Keys Auto
Center

STAFF REPORT

RE: 1618 N. Roosevelt Blvd #TP2022-0012
(Final Landscape Plan Review)

FROM: Karen DeMaria, City of Key West Urban Forestry Manager

LANDSCAPE PLAN PROPOSAL OVERALL
SCALE: 1/20" = 1'-0"

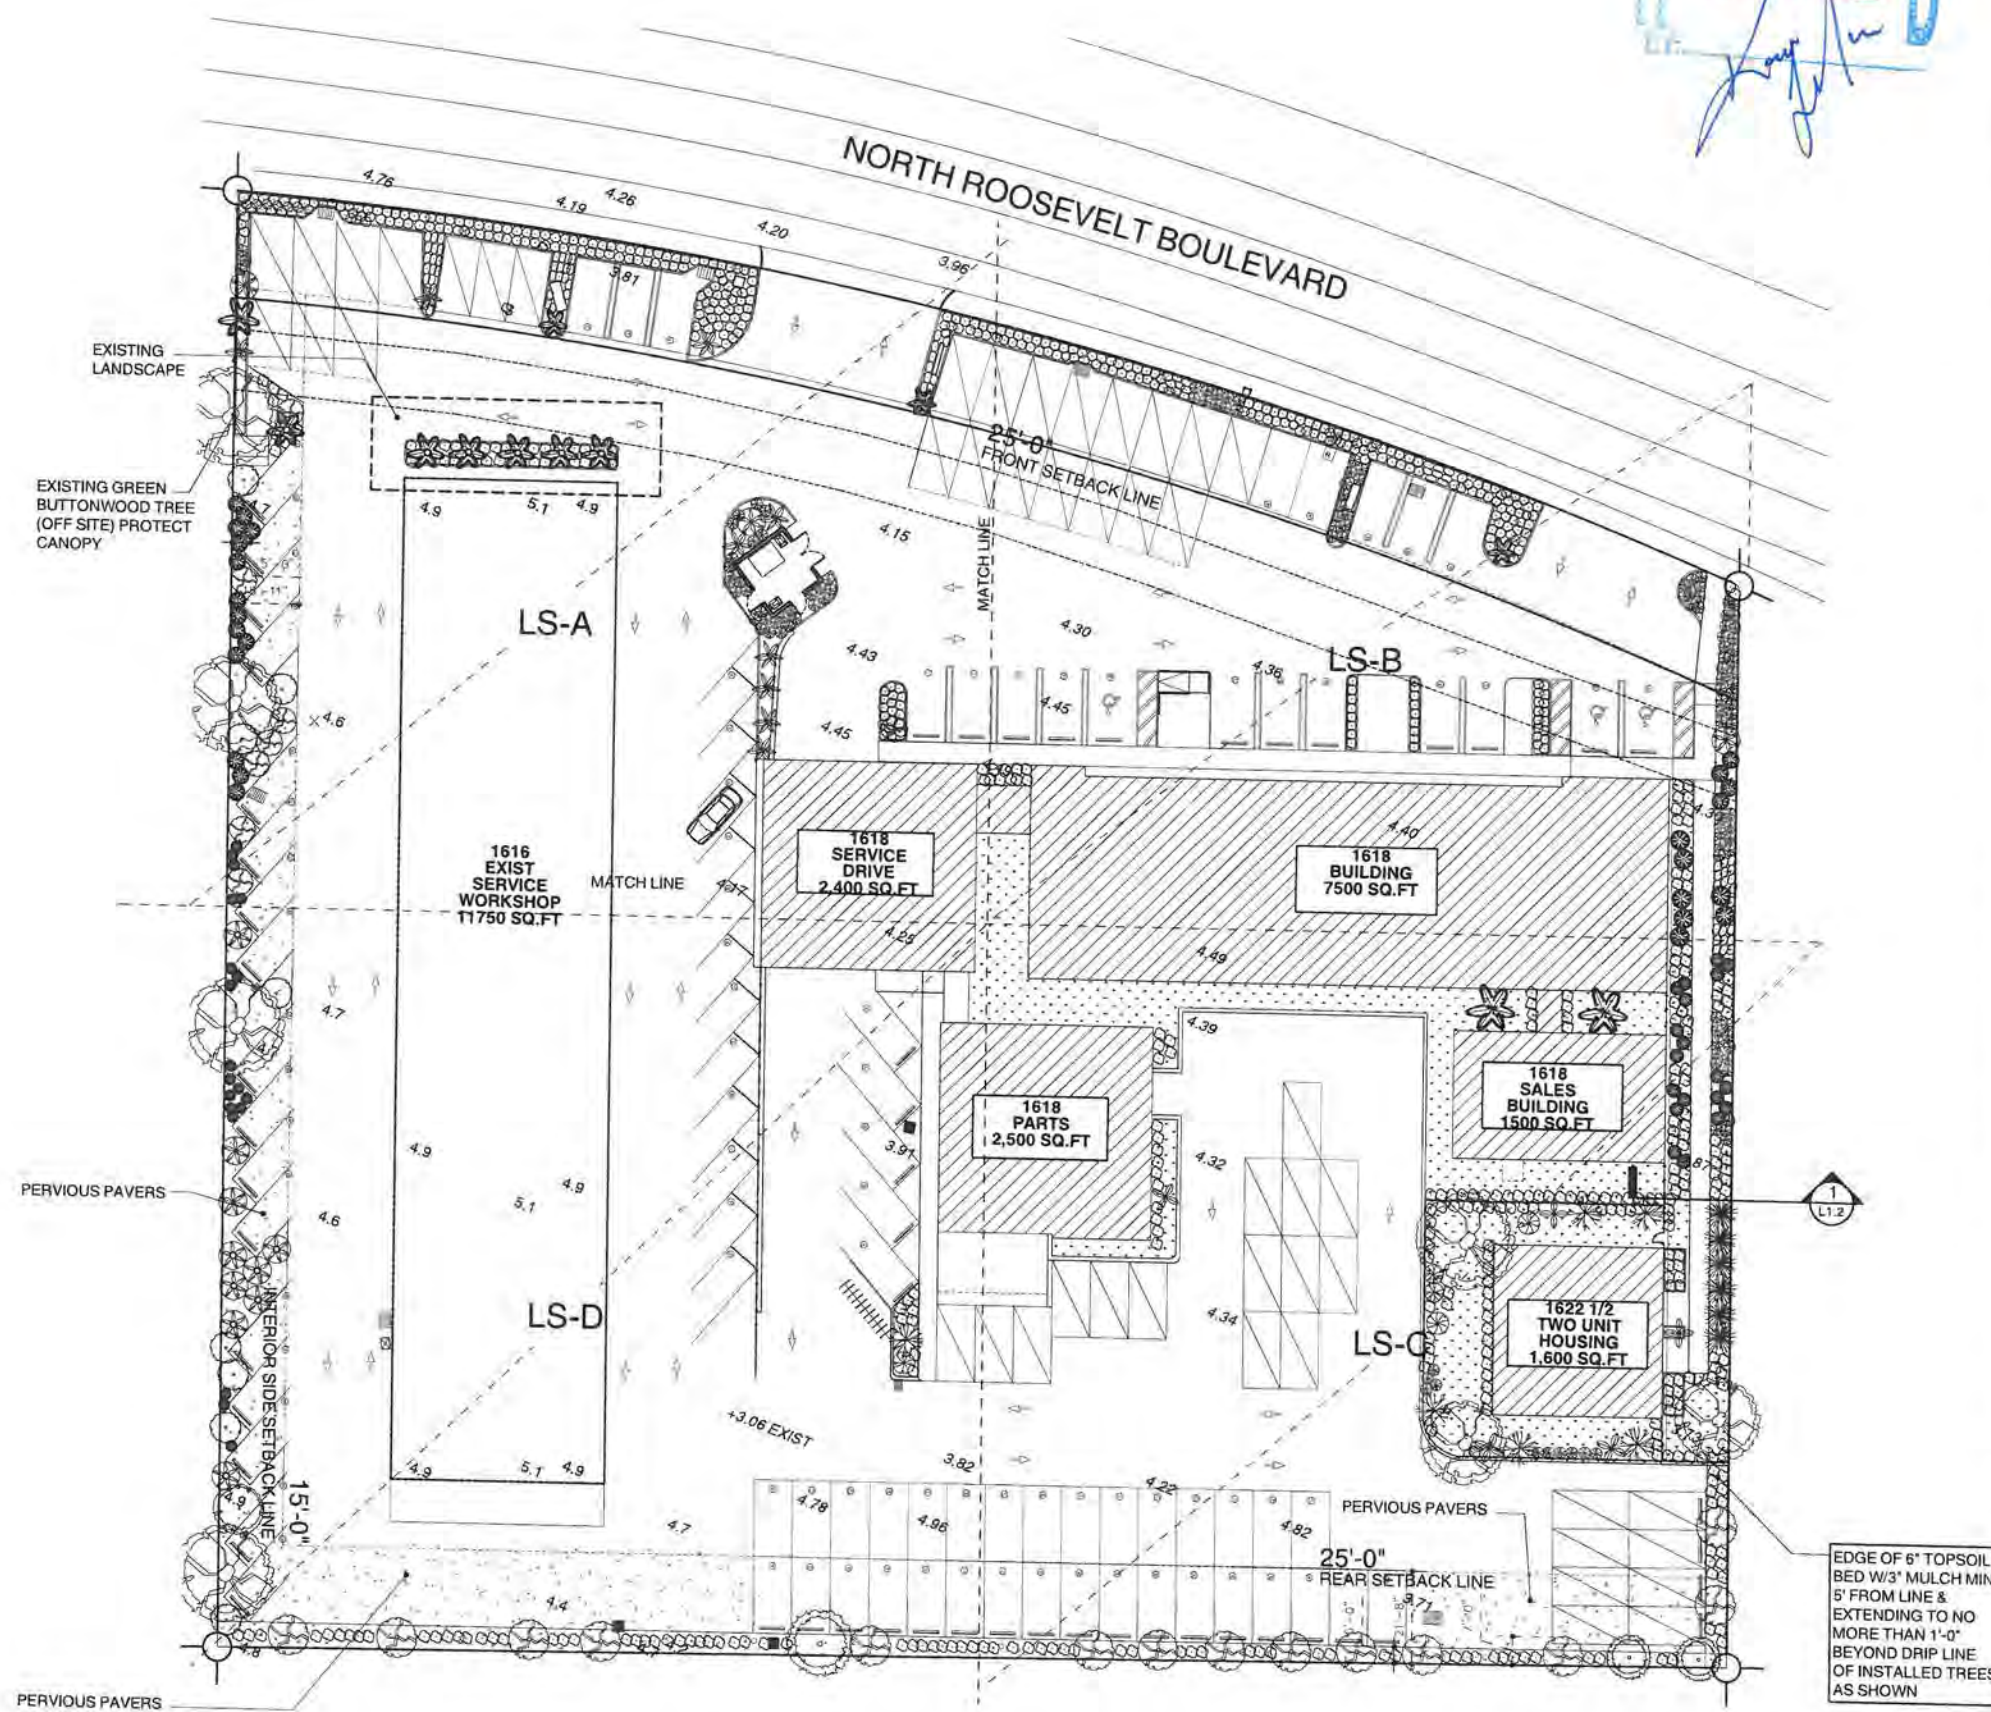
1. Sec 108-243: A landscape plan and a tree protection plan has been submitted. An irrigation plan as per Sec 108-515, has not been submitted.
2. Sec 108-289: The property is an existing, car dealership (disturbed uplands-commercial). The project will not be removing any regulated trees. Regulated palms are to be transplanted on the property.

3. Sec 108-346: As per the submitted plans, the open space percentage is 17%. This has not been verified. There are several Brazilian pepper trees, an invasive exotic plant, along the rear property line with the school that will be removed. Due to the seed source being in the soil, the property maintenance plan must include a statement regarding maintenance of the property to remove any invasive exotic plant species. **A waiver might be needed for open space.**

The east side buffer is approximately 5 ft wide therefore, 72 plant units per 100 linear feet are required for a total of 267 plant units. The plan proposes a total of 167 plant units. **Waiver required or add additional plants to the plan.** There is a sidewalk immediately adjacent to this buffer area with approximately an additional 80 shrubs being planted.

The south side buffer is approximately 5 ft wide therefore, 72 plant units per 100 linear feet are required for a total of 267 plant units. Three existing Strangler Fig trees are located in this buffer area and are to remain. Strangler Fig trees are an important canopy tree therefore, as per Sec 108-451, a two tree credit for each Strangler Fig tree has been given. The plan proposes a total of 251 plant units. **Waiver required or add additional plants to the plan.**

The west side buffer is approximately 2.5 ft wide therefore, 80 plant units per 100 linear feet are required for a total of 278 plant units. The plan proposes a total of 255 plant units. **Waiver required or add additional plants to the plan.**

6. Sec 108-412: The applicant states that 17% of the site will be landscaped. This has not been verified. Code requires a minimum of 20% of the building site area be landscaped and 70% of the vegetation shall be native vegetation. The landscape plan does include 70% native vegetation. **A waiver might be needed for minimum landscape area.**

7. 108-413, landscape requirement along street frontages. The property is 2.76 acres therefore, this section of the code requires 120 plant units per 100 linear ft in a 30 ft wide buffer area for a total of 464 plant units. The plan proposes approximately 260 shrubs planted in a 5 ft wide landscape strip along the N. Roosevelt Blvd sidewalk. The proposed landscaping also includes several island extension areas from the shrub landscape strip that include an additional 150 plants units that include shrubs and five palms. **A waiver is needed for buffer width and plant units.**

9. Sec 108-416, interior area landscaping. This section of code specifically looks at the planting of trees and requires that all areas not covered by buildings or hardscape will have grass, groundcover, shrubs or other landscaping materials. The application states 20,157 square feet of area or 17% is not covered by asphalt or buildings. Therefore, 10 canopy trees are required to be planted in the interior of the property. The landscape plan includes most of the canopy trees to be planted along the side buffer areas. The proposed landscape plan does include the planting of three Simpson Stopper trees, a subcanopy tree species, a Gumbo Limbo tree, and numerous palms in the interior area. **A waiver will be needed.**

11. Sec108-448: Landscape strips are to be covered in soil and mulch. Sod has been proposed in some larger areas and pervious pavers are also proposed. No other groundcover plants have been proposed. **A waiver might be needed.**

12. Sec 108-450: Landscape screening has been provided.
13. Sec 108-452: This section reviews line of site areas. There is a concern regarding the use of vegetation along the N. Roosevelt Blvd landscape area due to the nature and shape of the roadway in this area. The proposed landscape plan provides minimal landscaping in this area with cocoplum shrubs that easily be maintained at a 24 inch height.

16. Sec 108-515: Irrigation plan required. An irrigation plan has not been submitted. A note on the landscape plans states; "all areas to be irrigated w/drip irrigation only system (by others) to be included in permit." **A condition of the approval is needed.**

1. Due to the rush review of the submitted landscape plan, final approval of a corrected and updated landscape plan is required from the Tree Commission to include additional plantings, as requested by the Planning Director, and Urban Forestry Manager.
2. An irrigation plan is required prior to placement on City Commission agenda.
3. A landscape maintenance plan and palm transplantation plan is required.

TREE PROTECTION PLAN DETAIL

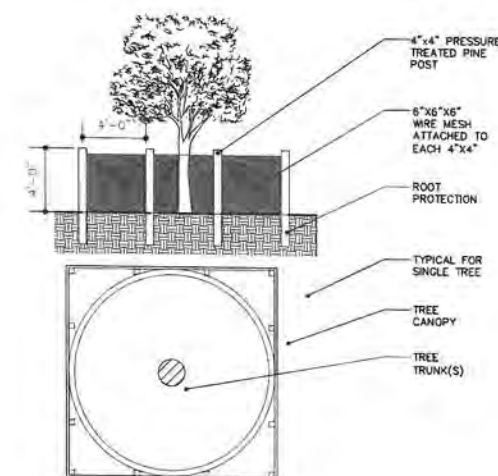
The existing site map shows all the documented vegetation on the property. The plan misidentifies the scientific name on a few species. This will need to be corrected prior to Final Landscape Plan review by the Tree Commission.

No regulated trees or palms are being removed. Nine Royal Palms will be relocated on the property. A transplant plan will need to be provided.
